**SITE ADDRESS:** 1312 El Paseo de Saratoga and 1777 Saratoga Avenue

**RE. File No. PDA20-006-02** Planned Development Permit Amendment to allow changes to Buildings 1, 2, and 4 within the approved El Paseo Signature Project (File No. PD20-006) on an approximately 10.76-gross acre site.

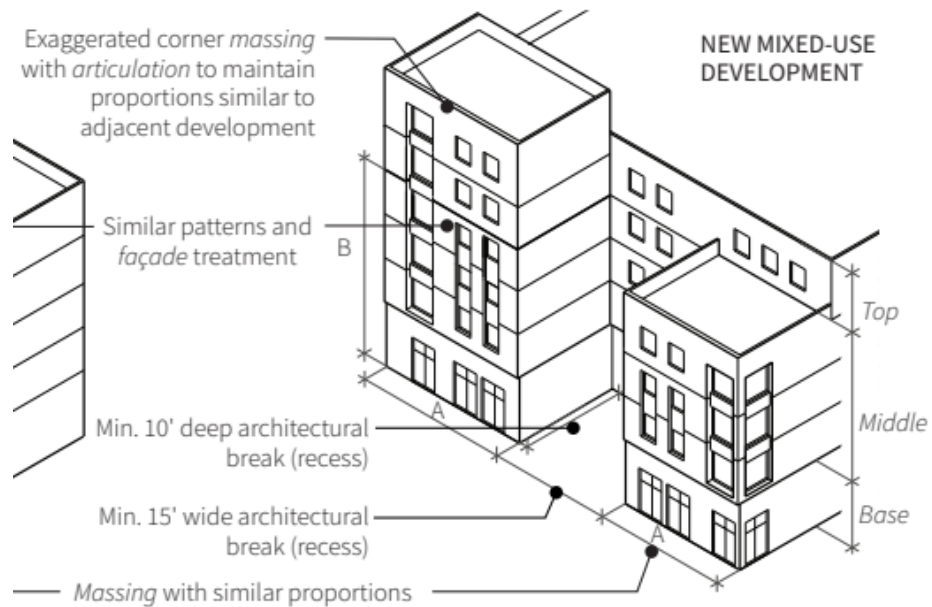
*Staff Comments: This design standard applies to both Buildings 1 & 2 and Building 4. See the figures below for reference.*

- *Buildings 1 and 2 front on an open space area. Therefore, they must include two of the above elements for each building. A corner plaza is already provided. Therefore, one additional element is required for each building.*
  - *Building 4 is located at the intersection of Saratoga Avenue and Lawrence Expressway, a signalized intersection. Upon resubmittal demonstrate conformance with the above standard.*
- Standard 2 – For streetwalls more than 200 feet in length, provide at least one recess or projection in the façade that is at least:
- 15 feet wide and 10 feet deep for residential, commercial, and mixed-use developments
